**DOCKET 50-255 - LICENSE DPR-20 - PALISADES PLANT
RESPONSE TO NOTICE OF VIOLATION FOR TWO VIOLATIONS IN NRC
INTEGRATED INSPECTION REPORT NO. 50-255/96014(DRP)**

**CONSUMERS POWER COMPANY
PALISADES PLANT
DOCKET 50-255**

**RESPONSE TO TWO VIOLATIONS FROM NRC INSPECTION
REPORT NO. 50-255/96014 (DRP) DATED JANUARY 22, 1997**

Y-50

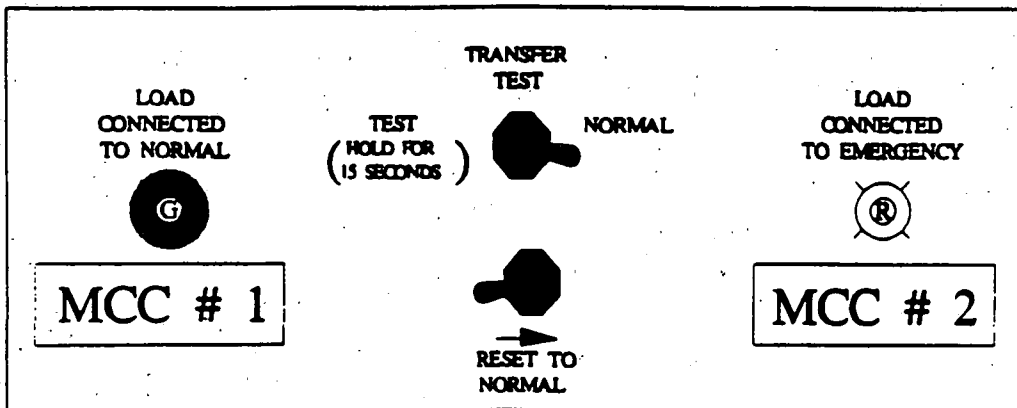
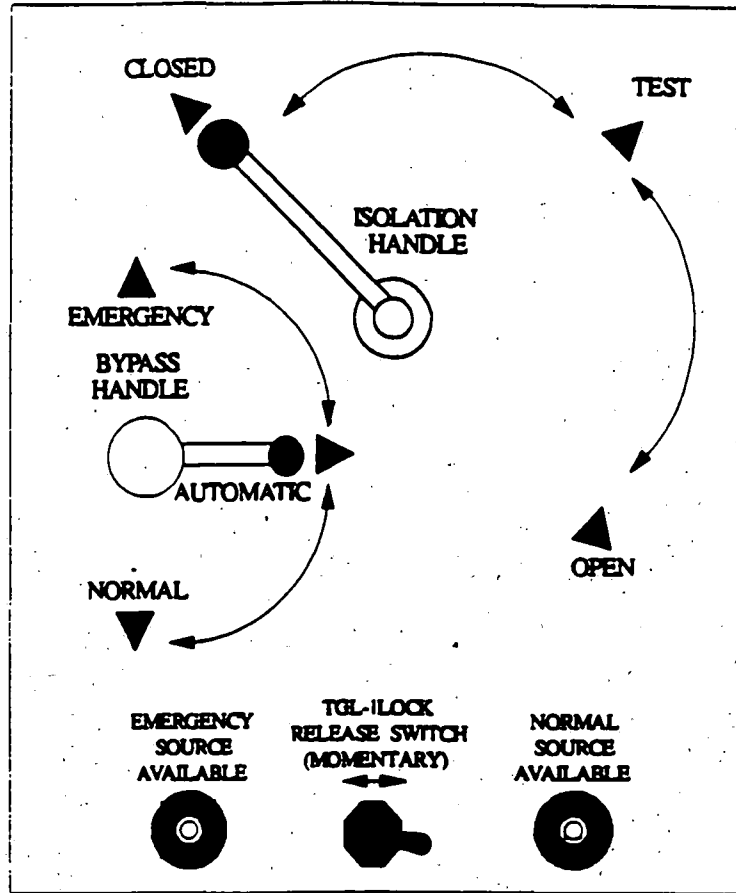
did not obtain a copy of the procedure to review, and failed to establish the full electrical maintenance work scope. Subsequently, Operations decided to implement a portion of SOP 30 that configured the Y50 switch from automatic to normal, but did not recognize the need to place the isolation handle to "open" (see attached sketch). This configuration fulfilled only one of two alignment steps specified in the PPAC.

The Shift Lead SRO and the AO went to perform the alignment of Y50. They observed the isolation handle, the source light indication and the switch's physical position, but they did not recognize their indications were different than expected. The AO placed the Y50 bypass handle from normal to automatic. Because the isolation handle had not been restored to the "close" position, Y50 failed to transfer and Y01 was de-energized.

Periodic activity, SPS050, will be revised to use the terminology of operating procedure, SOP 30, and to make the steps to align automatic transfer switch, Y50, an Operations responsibility with the appropriate sign offs.
